H-11163

DESCRIPTIVE REPORT

General Locality NORTHERN CLARENCE STRAIT

Sublocality Bush Island to Barnacle Rock

Table 1 H11163 Survey Limits

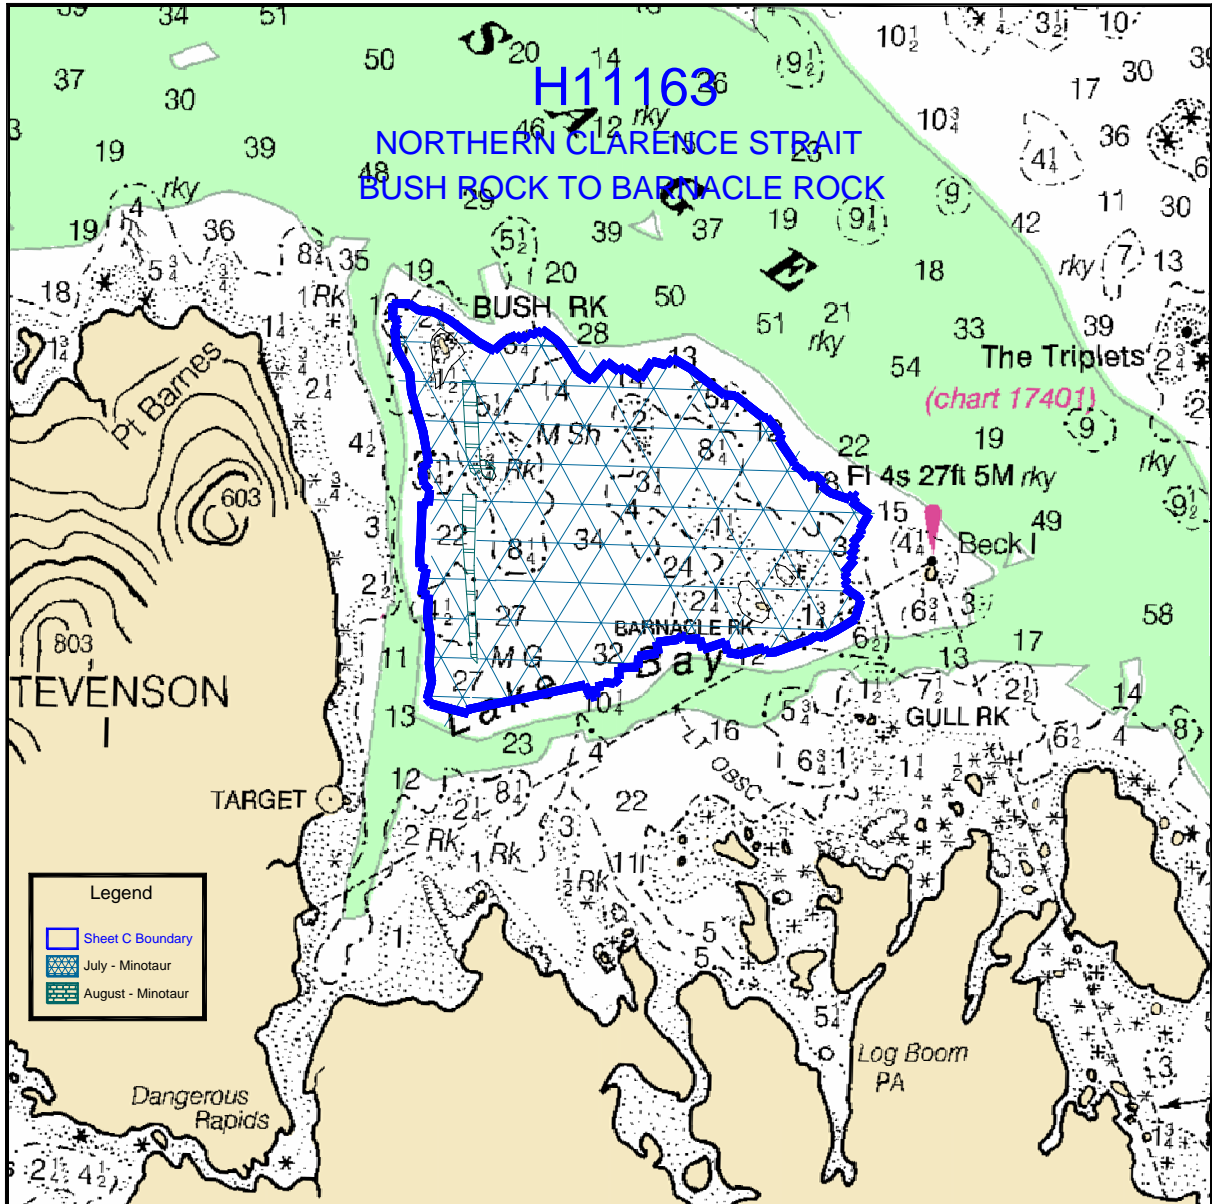
H11163 (Sheet C), is bounded by the coordinate listing below, and encompasses Bush Rock to Barnacle Rock.¹

¹ Concur with clarification. The coordinates listed define the sheet limits. Refer to Surdex for the survey area. The western survey boundary is west of Bush Rock and the eastern boundary is east of Barnacle Rock.

² Limits of the actual area surveyed are roughly defined by the following points:

Lat 56/03/50N, Lon 132/55/10W

Lat 56/03/50N, Lon 132/50/00W

Lat 56/02/15N, Lon 132/50/00W

Lat 56/02/15N, Lon 132/55/10W
